**SECTION 00 90 04
BIDDING AND CONTRACT REQUIREMENTS
ADDENDUM NUMBER 4**

Issued: October 12, 2023

Re: ADDENDUM NUMBER (4) TO THE BIDDING DOCUMENTS FOR

**McHenry County College
University Center at MCC**
Architect's Project Number: 22-050

WIRE LEGEND	
	PLENUM-RATED F/UTP SHIELDED CAT6A CABLE
	1/2" SHIELDED, PLENUM RATED SPEAKER CABLE

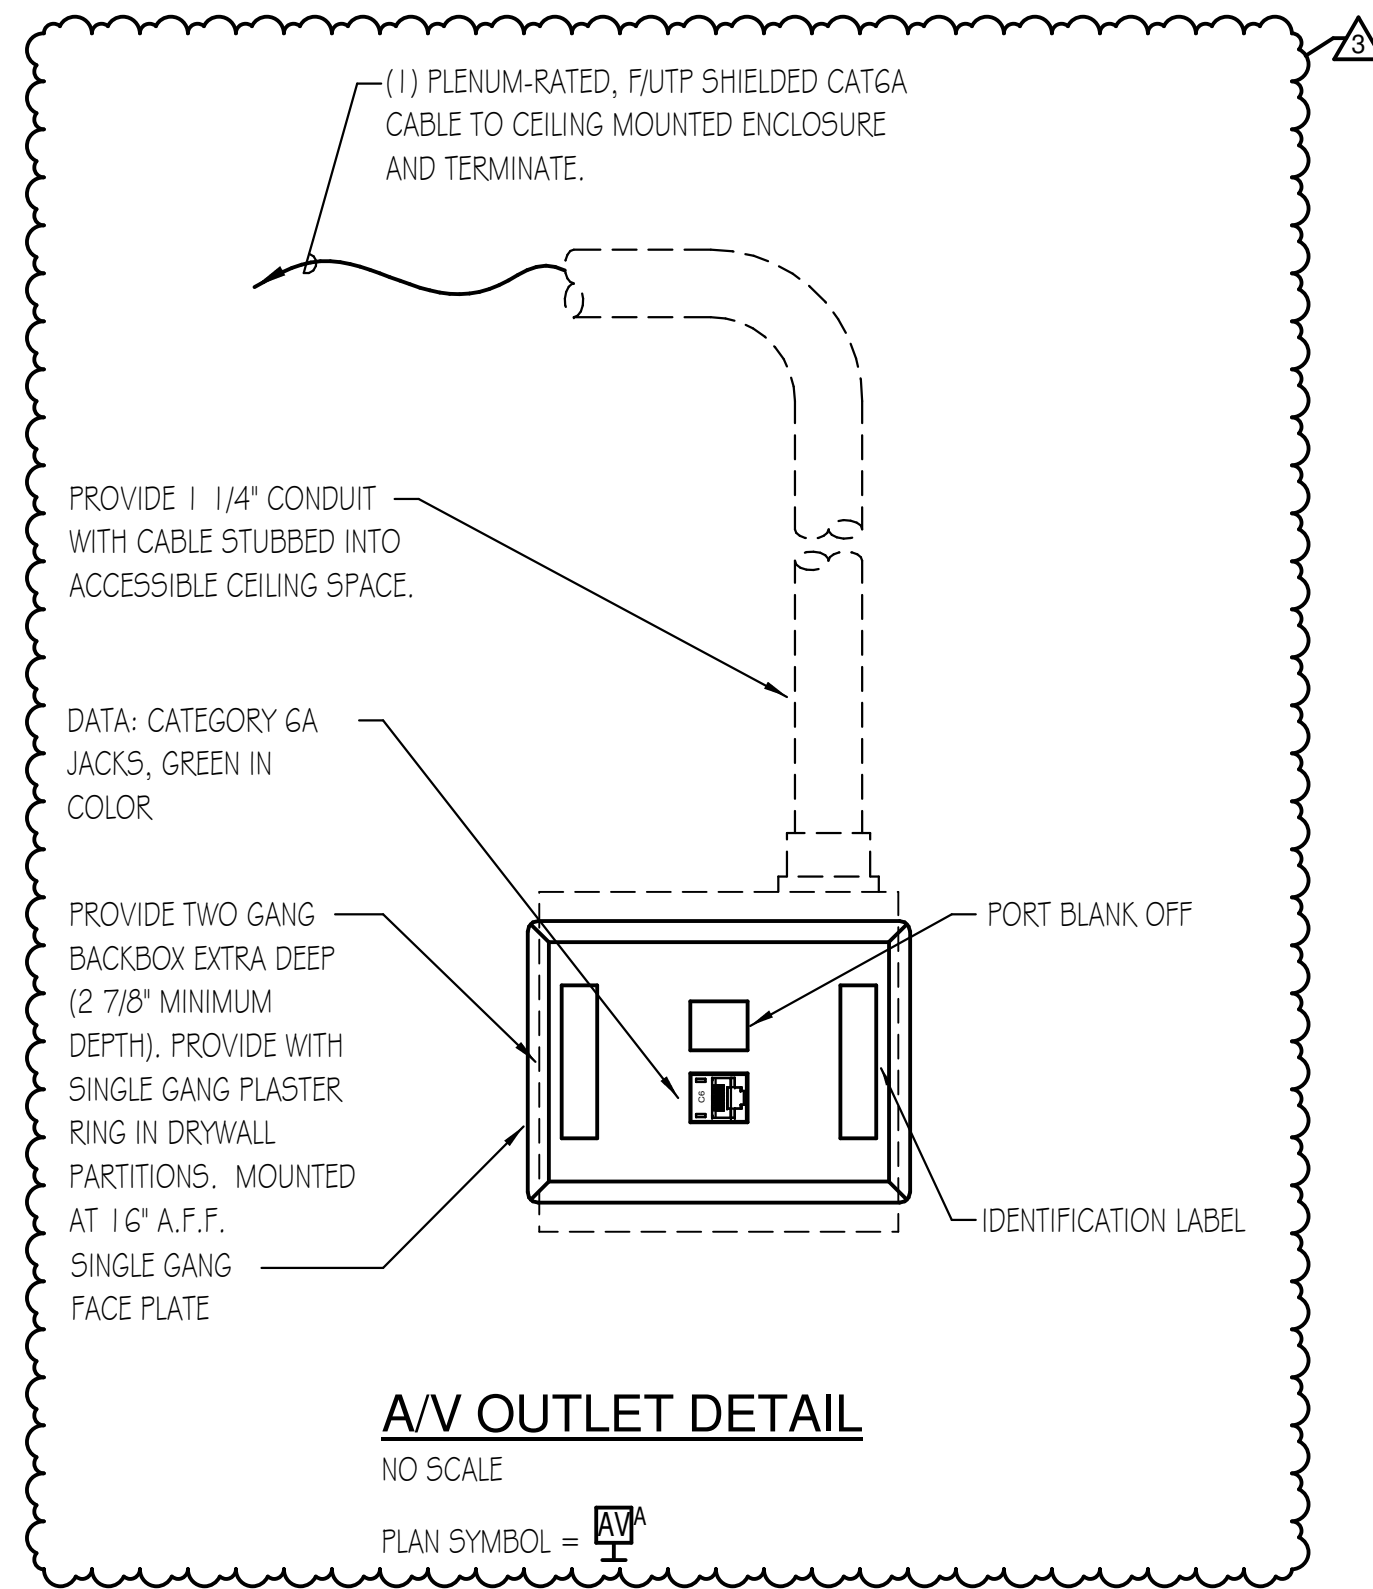
- C. **ADD** note #5 to 'LUMINAIRE SCHEDULE'.
- 5. E7.10
 - A. **REVISE** 'TYPICAL NETWORK RACK DETAIL' to indicate 2" innerduct for routing of fiber optic backbone cable.
- 6. E7.30
 - A. **REVISE** 'A/V RECEIVER OUTLET DETAIL'.
 - B. **REVISE** 'A/V TRANSMITTER OUTLET DETAIL'.
 - C. **ADD** 'A/V OUTLET DETAIL'.
